# Access Compliance Report

## Public Rights-of-Way

| Intersection ID: 7410                   | Main Street: SQUIRREL_HILL_RD | Cross Street: WHITE_PLAINS_RD           | Location: NE           |
| ADA ID: 567DEF8B8FF3                    | Ramp Type: BlendTrans1        | Initial Pass/Fail: Fail                 | Overall Compliance: No |

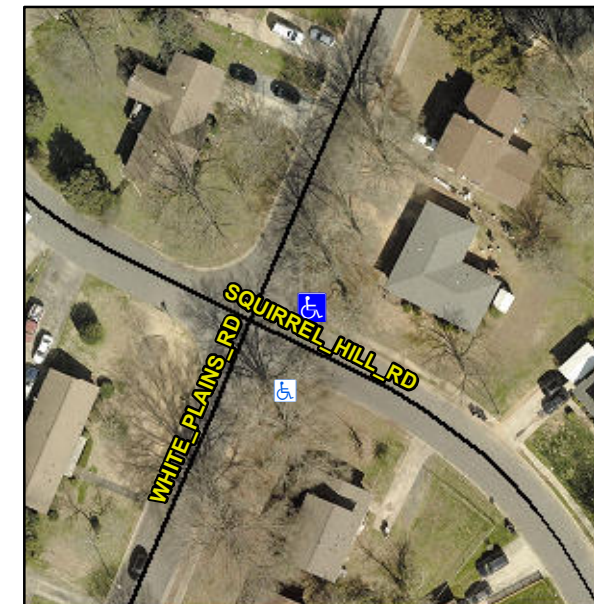
| Severity Score: 8.75                    |                               |   |                        |

**Not Found, R304.5.1**

| Compliance | Description           | Data  | Compliance | Description                 | Data |
|------------|-----------------------|-------|------------|-----------------------------|------|
| No         | Ramp Width (in)       | 41.0  | Yes        | BlendTrans XSlope (%)       | 0.1  |
|            |                       |       | No         | Curb Slope (%)              | 22.6 |

**Remove & Replace Curb Ramp With Two New Directional Ramps or Equivalent.**

Total Cost: \$ 3200.00
